SITE PLAN REVIEW

LOT NO. 23 REGISTERED PLAN 43M-2013

LOT GRADING PLAN
65 DEGREY DRIVE

Client: GREENYORK HOMES
Project: DEGREY DRIVE, CITY OF BRAMPTON

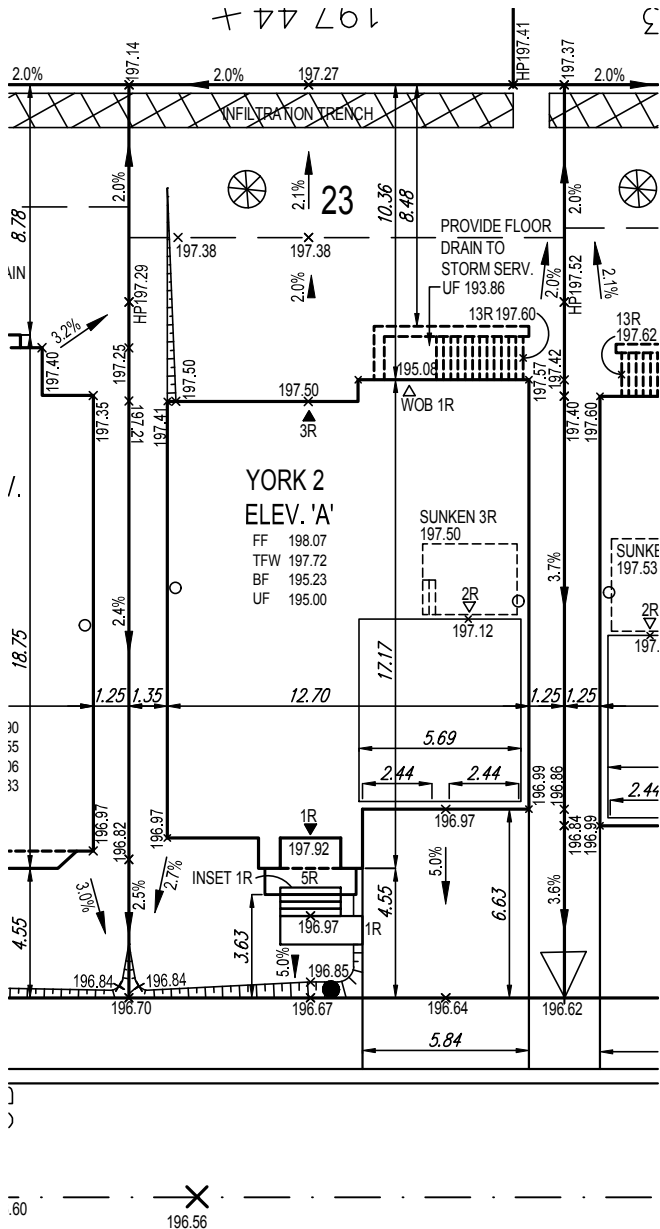
THE PROPOSED LOT GRADING AND DRAINAGE IS APPROVED AS BEING IN CONFORMITY WITH THE OVERALL APPROVED GRADING PLANS FOR THE SUBDIVISION.

NO COMMENT REVIEWED BY SK COMMENTS AS NOTED DATE May 23, 2017
